Informal meeting on Code of Practice for Packing of Cargo Transport Units

Blocking and bracing material and arrangements

Submitted by ETS Consulting and MariTerm AB

This document proposes changes to Annex 7, clause 2.3 on Blocking and bracing material and arrangements and clause 4 on Securing of cargo in CTUs.

Figure 7.3 Centre gap with transverse ~~bracing~~ blocking

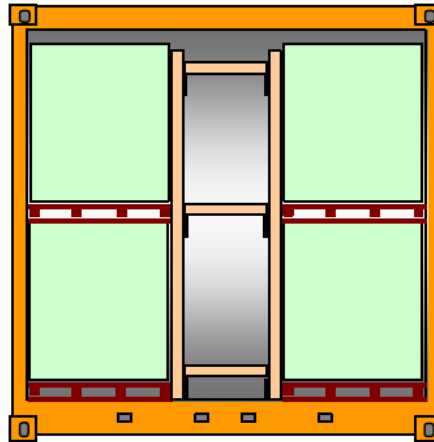
- 2.3.1 Blocking, ~~bracing or shoring~~ is a securing method, where ~~either the cargo is stowed directly against strong structural elements of the CTU or additional materials~~, e.g., timber beams and frames, empty pallets or dunnage bags are ~~used to filled in the~~ gaps between the cargo and solid boundaries of the CTU or ~~into~~ gaps between different packages (see figure 7.3). Forces are transferred in this method

by compression with minimal deformation. ~~Inclined bracing or shoring arrangements bear the risk of bursting open under load and should therefore be properly designed.~~ In CTUs with strong sides, ~~and where if possible,~~ packages should be stowed tightly to the boundaries of the CTU on both sides, leaving the remaining gap in the middle. This reduces the forces to the ~~bracing~~ blocking arrangement, because lateral g-forces from only one side will need to be transferred at a time.

Figure 7.4 Shoring arrangement showing cross beam overlap and diagonal braces

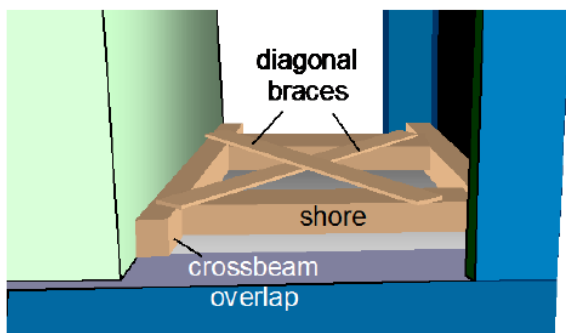
2.3.4 A bracing or shoring arrangement temporary wooden structure should be designed and completed in such a way that it remains intact and in place, also if compression is temporarily lost. This requires suitable uprights supports or benches supporting the actual shores blocking elements, a proper joining of the elements by nails or clamps and the stabilising of the arrangement by diagonal braces as appropriate (see figures 7.6 and 7.5). Inclined blocking arrangements bear the risk of bursting open under load and should therefore be properly designed.

Figure 7.6. Components of a temporary wooden blocking arrangement

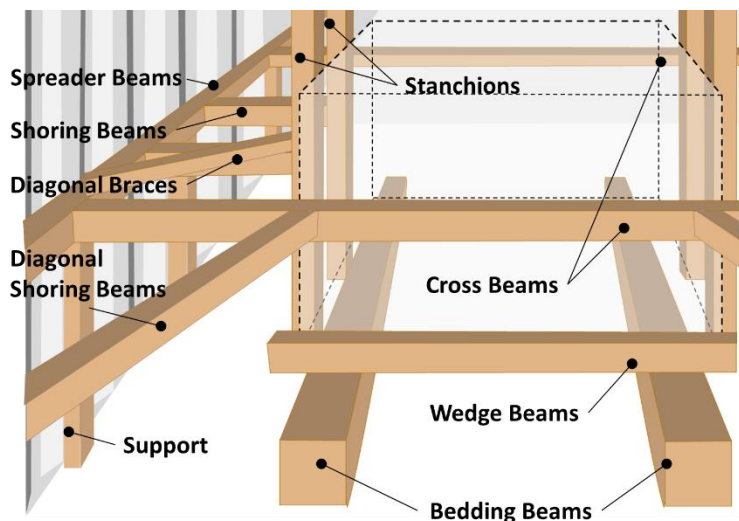
- The principle of securing the load against the corner posts of the container to prevent longitudinal displacements, as shown in 2.3.4, figure 7.6, cannot be applied to the container structures currently used. Therefore, this clause should be reformulated.
- The example of securing a load to the corner posts of the container door opening shown in figure 7.32 is not correct, as the corner posts do not protrude beyond the side walls of the container.

- Shoring beams are generally under compression
- Spreader and bedding beams run longitudinally
- Stanchions stand vertically
- Cross beams and door shoring bars run transversally

Figure 7.6 General layout of fence battens for door protection in a CTU

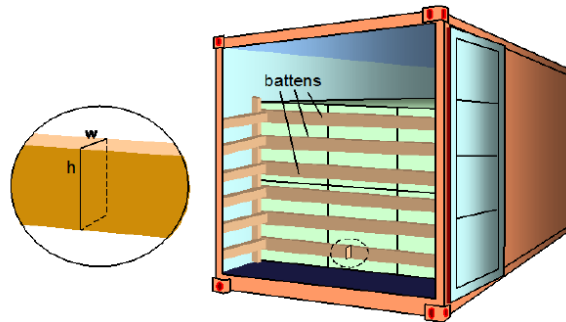
2.3.4 Transverse battens in a CTU, intended to restrain a block of packages in front of the door or at intermediate positions within the CTU, should be sufficiently dimensioned in their cross section, in order to withstand the expected longitudinal forces from the cargo (see figure 7.6). The ends of such battens may be forced into solid corrugations of the side walls of the CTU. However, preference should be given to brace them against the frame structure, such as bottom or top rails or corner posts. Such battens act as beams, which are fixed at their ends and loaded homogeneously over their entire length of about 2.4 metres. Their bending strength is decisive for the force that can be resisted. The required number of such battens together with their dimensions may be identified by calculations, which is shown in appendix 4 to this annex.

Figure 7.7 Properly cut and nailed wedges

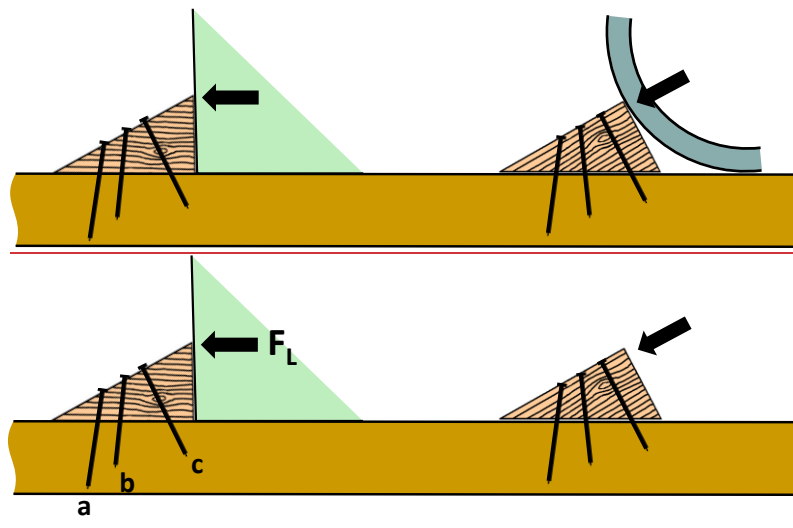
2.3.5 Blocking ~~by nailed on scantlings~~ that is secured using mechanical fastenings on bedding or spreader beams should be used for minor securing demands only. The different types of fixing will provide a range of shear strength, depending on the type, configuration and size of the ~~nails~~ fastener used.

For example, ~~the shear strength of a blocking arrangement secured using nails may be estimated to take up a blocking force between 1 and 4 kN per nail.~~ ~~Nailed~~ nailed on wedges may be favourable for blocking round shapes like pipes. Care should be taken that wedges are cut in a way that the direction of grain supports the shear strength of the wedge. Any such timber beams or wedges should only be nailed to bedding beams or timbers placed under the cargo (see figure 7.7). Wooden floors of closed CTUs are generally not suitable for nailing. Nailing to the softwood flooring of flatracks or platforms and open CTUs may be acceptable with the consent of the CTU operator (see figure 7.7).

Figure 7.8 Withdrawal loads

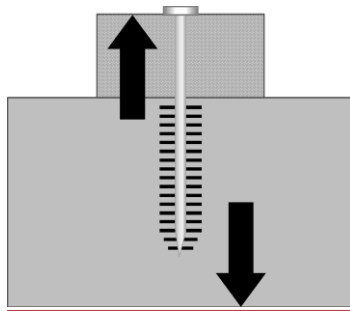
1. Nails in use are subjected either to withdrawal loads or lateral loads (as shown in figures 7.8 and 7.9), or a combination of the two. Both withdrawal load and lateral load are affected by the wood, the nail, and the condition of use.

Figure 7.10 Lateral displacement and effect on nail

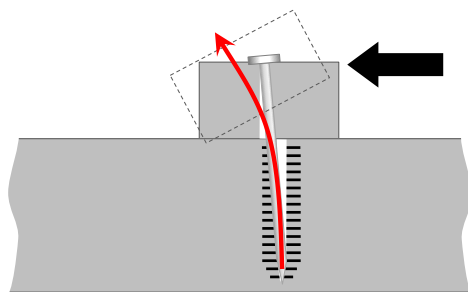
2. Any lateral load on a blocking element that is affixed using nails will result in the hole formed in the timber as the nail is driven in will distort and the blocking element rotates, thus levering out the nail (see figure 7.10). As shown in Figure 7.11, the force required to extract the nail diminishes significant already at relatively small displacements, but the effect is less prominent for ringed or spiral nails. The diameter of the nail dictates the resistance to lateral loads; a small displacement laterally will cause the nail to bend and the depth of penetration is of lesser importance. However, if there is a larger displacement, then the nail will be subjected to both lateral and withdrawal loads.

Figure 7.120 Depth of penetration

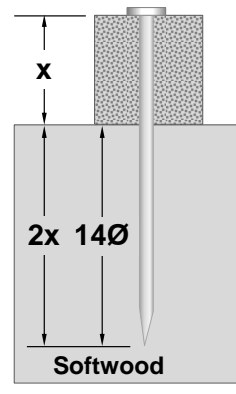
- .1 The lateral nail load is also related to the depth of penetration of the nail in the foundation member or member receiving the point. There are two general rules for the depth of penetration:
- . (a) The depth of penetration generally recommended for plain-shank nails to develop full load varies but is about 14 times the nail diameter for the softer woods¹.

- (b) The depth of penetration can also be calculated so that the shank penetrates to a depth of twice the thickness of the affixed member. Thus, the length of the nail should, if possible, be three times the thickness of the blocking element to be attached and that the nail is fully driven in.

Figure 7.14

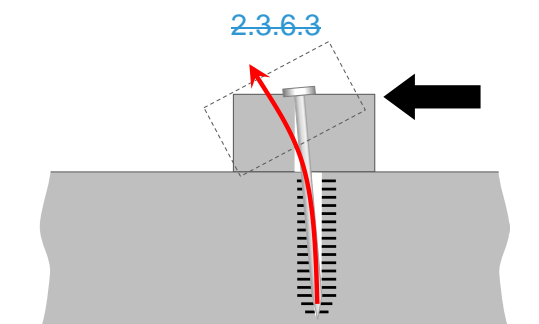
55also compares the force required to withdraw the nail for Spiral and ringed nail shanks.2.3.6.33 Finally the effectiveness of the nail will depend on the timber used and it should be properly seasoned:

Figure 7.35 Boundary blocking arrangement

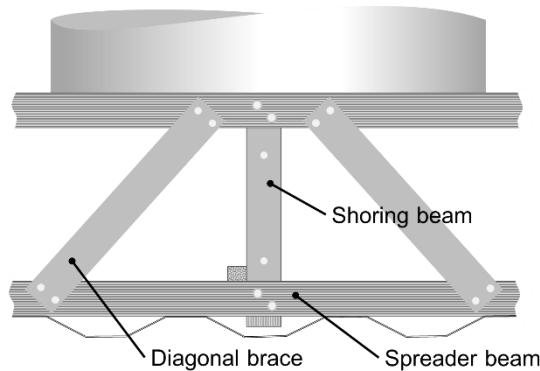
4.1.7.2 Additional shoring may be made against the boundary side and front walls so long as the forces are distributed by spreader beams as shown in Figure 7.35 and Figure 7.36.

Figure 7.32 Blocking in a strong boundary CTU

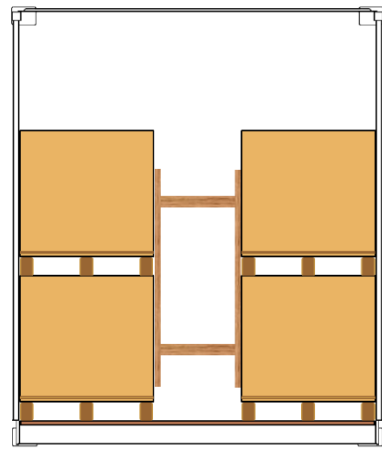
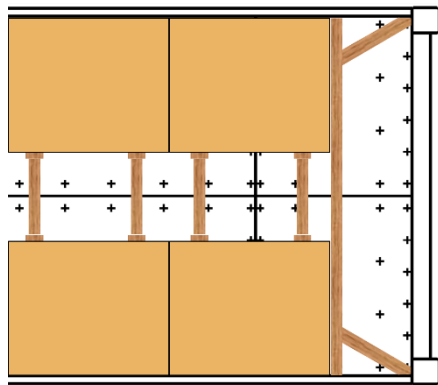
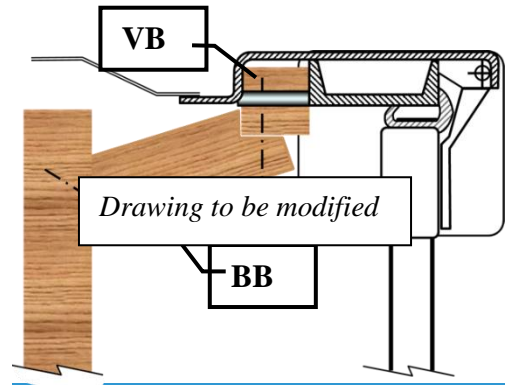
4.2.4 Critical situations may arise, e.g., with a fully packed freight container in road transport, where longitudinal securing should be able to withstand an acceleration of 0.8 g. The longitudinal wall resistance factor of 0.4 should be combined with a friction factor of at least 0.4 for satisfying the securing balance. If a balance cannot be satisfied, the mass of cargo should be reduced, or the longitudinal forces transferred to the main structure of the container. The latter can be achieved by intermediate transverse fences of false bulkheads of timber battens cross beams (see subsection 2.3.4X of this annex) or by other suitable means. (see figure 7.32). When bracing against the rear corner frames, vertical timber battens (VB) should be inserted into the shoring slots between the slot bars and the bracing battens (BB) fitted against this. Where required nails or other fixings can be used to stabilise the bracing battens.

Figure 7.42 Wooden structure for blocking against the end wall of flat rack

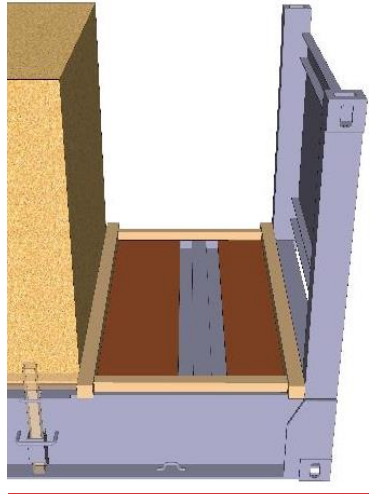
- 4.2.8 When a temporary wooden structure is used to block the cargo against the end walls of platform and flat rack type CTUs, this should be supported against the corner posts and the shoring beams should be placed as far out towards the sides as the cargo permits. Stanchions, produced from wooden beams with a cross section of 75x75 mm, may often be inserted into pockets along the sides of the platforms to prevent the cargo from sliding sideways.
